- Request - Special Use Permit for a tobacco shop
- Location - 1122 N. Byrne Road Unit 14
- Applicant - Mohammed Abdonagi
1122 N. Byrne Road, Unit 14
Toledo, OH 43607
- Owner - Sanyoura Management LTD
1122 N Byrne Road Unit 12
Toledo, OH 43607
- Architect - Kevin Brown
CENIC Architecture
325 Superior St. Unit A
Rossford, OH 43460

The staff recommends that the Toledo City Plan Commission recommend approval of SUP25-0008, a Special Use Permit for a Tobacco shop located at 1122 N Byrne Road, to the Toledo City Council, for the following **two (2) reasons**:

SPECIAL USE PERMIT
TOLEDO PLAN COMMISSION
REF: SUP25-0008
DATE: March 13, 2025
TIME: 2:00 P.M.

SITE PLAN
SCALE: 1" = 30'-0"

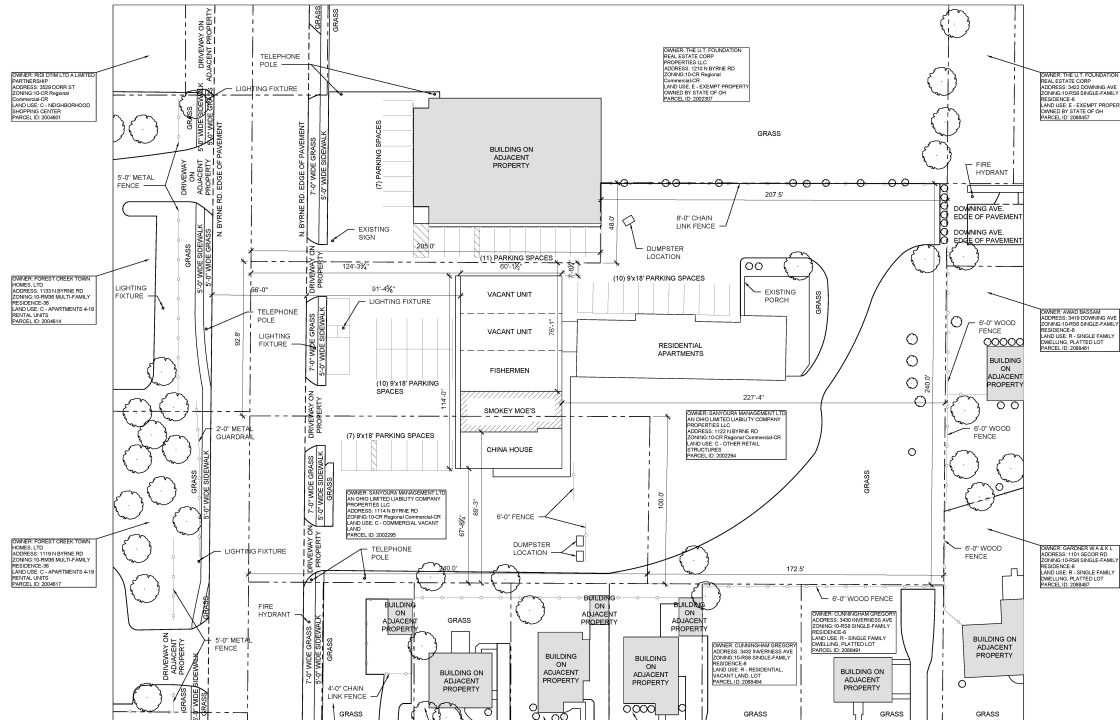
- a. Tobacco shops follow *Off-Street Parking schedule "B"*, requiring one (1) parking space for every 300 square feet of business tenant space plus one (1) bicycle parking for every ten (10) car parking spaces. The total tenant space is 1,327 square feet, and requires four (4) car parking spaces and one (1) bicycle parking space. The site plan depicts seventeen (17) parking spaces for all five business tenant units. The site plan does not identify bicycle parking and shall be shown on a revised site plan. The proposed tobacco shop shall provide a minimum of one (1) two-slot bicycle parking as a condition of approval.

- b. A minimum of one (1) van parking space for physically disabled persons, along with appropriate signage, is required. This is not reflected on the site plan and is a condition of approval.

- c. Dimensions for all driveways, drive aisles and parking spots are not shown on the submitted site plan. These dimensions shall be shown on a revised site plan in accordance to TMC§1107.1911.

- d. At least one main entrance of any commercial building shall face and open directly onto a five-foot (5') wide connecting walkway to the street sidewalk proving a logical route for pedestrians from the right of way per TMC§1109.0204(A). **Not existing on site. This is a condition of approval and shall be shown on a revised site plan.**

10. A revised site plan shall be submitted to the Plan Director and Division of Transportation depicting all parking spaces and drive aisles compliant with the dimensional requirements of TMC§1107.1911.

13. One (1) bicycle parking space with a minimum of two-slots shall be provided pursuant to TMC§1107.0400. **Shall be depicted on revised site plan.**
14. One (1) van parking space designated for physically disabled persons shall be provided and in conformance with TMC§1107.1700 standards. **Shall be depicted on revised site plan.**

16. Per TMC§1109.0204(A). At least one main entrance of any commercial building shall face and open directly onto a five-foot (5') wide connecting walkway to the street sidewalk proving a logical route for pedestrians from the right of way. **Shall be depicted on a revised site plan.**

17. Whenever a parking lot extends to a property line, sidewalk, planting strip, or building, a wheel stop device consisting of a concrete stop, a permanent concrete curb, an expanded sidewalk or other suitable restraint as approved by the Planning Director must be installed to prevent any part of a parked motor vehicle from extending beyond the property line, overhanging a pedestrian walkway, or sidewalk, or damaging any structure or landscaping (TMC§1107.1907(A)). **Not acceptable as existing on site and shall be indicated on revised site plan.**

18. Dumpsters and trash receptacles shall be screened with a minimum six-foot (6') height wood fence and may not be located in any required setback or landscape buffers and as far from residential areas as possible per TMC§1108.0203(G). **Not acceptable as existing on site, shall be shown on revised site plan.**
